RE: Response to January 17, 2023 Notice of Incomplete Application S.A. Dunn Mine and C&D Facility DEC #4-3899-00006 Part 360 Permit Renewal and Modification; MLR Permit Renewal and Modification

Civil & Environmental Engineering, Land Survey, and Landscape Architects, PLLC (CEE) and GHD have prepared this letter in response to comments received from the New York State Department of Environmental Conservation, dated January 17, 2023, regarding the Part 360 Permit Renewal and Modification Application and Mined Land Reclamation (MLR) Permit Renewal and Modification Application for the S.A. Dunn Mine and Construction & Demolition Debris (C&D) Facility (Dunn Facility).

APPENDIX D

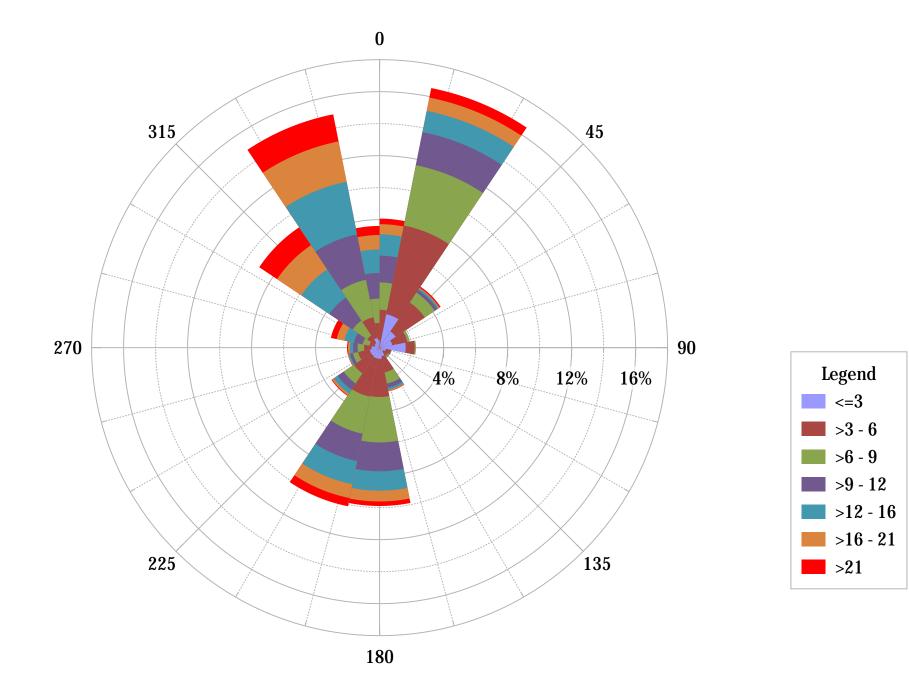
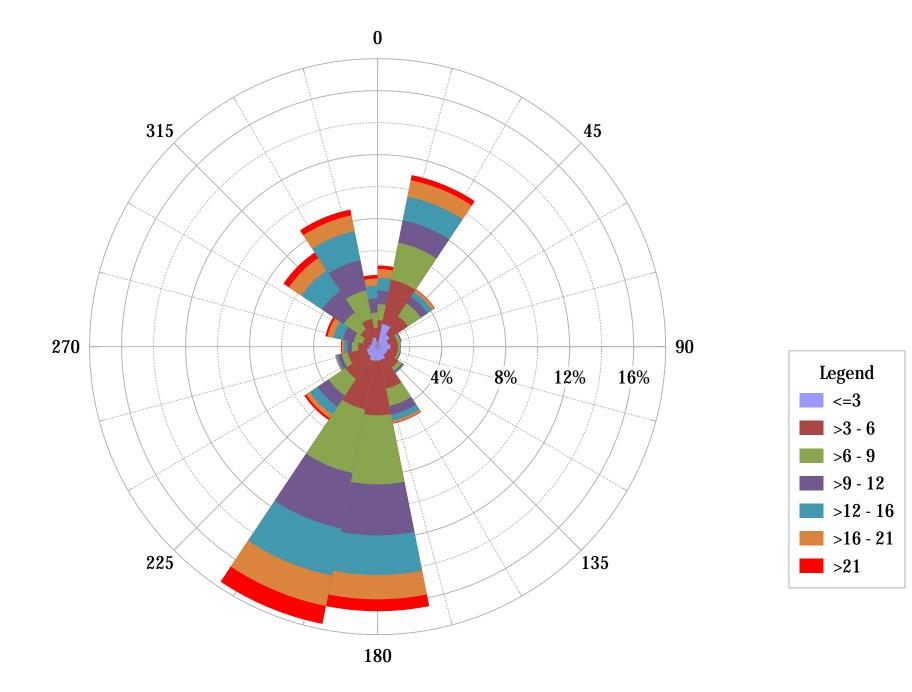
Moreover, with respect to PM, estimating emissions is not necessary in this instance because there is readily available data from the monitoring equipment on property that is adjacent to the Dunn Facility and within a disadvantaged community. In the hierarchy of estimating emissions, monitoring data is preferred over estimating emissions using emissions factors. Since 2019, the Department has collected PM10 data from the Rensselaer City School adjacent to the Dunn Facility to the north and compared the results to the Albany County Health Department monitor location to the west of the Dunn Facility. With minor exceptions, PM10 levels at the Rensselaer City School are consistently lower than those at the Albany County Health Department, and well below applicable standards protective of public health. This information is addressed in detail in Appendix F to Attachment D (EAF) to the Dunn Facility's January 13, 2022 permit application submission. The Department also maintains a summary of this information at https://www.dec.ny.gov/chemical/117071.html#Dust. This page has recently been updated to include 2022 data and confirms that PM levels in the disadvantaged community proximate to the Dunn Facility are far below established health standards, and typically lower than PM levels recorded at the Albany County Health Department monitor location to the west of the Dunn Facility.

In addition, on-site meteorological data for 2021 and 2022 was used to generate the wind roses at Appendix D. The wind roses indicate that the wind direction is from the south to the north (from the Dunn Facility towards the school) a significant portion of the time. Therefore, if measurable PM was being emitted from the Dunn Facility, it would be detected by the nearby monitoring device at the school. However, that is not the case.
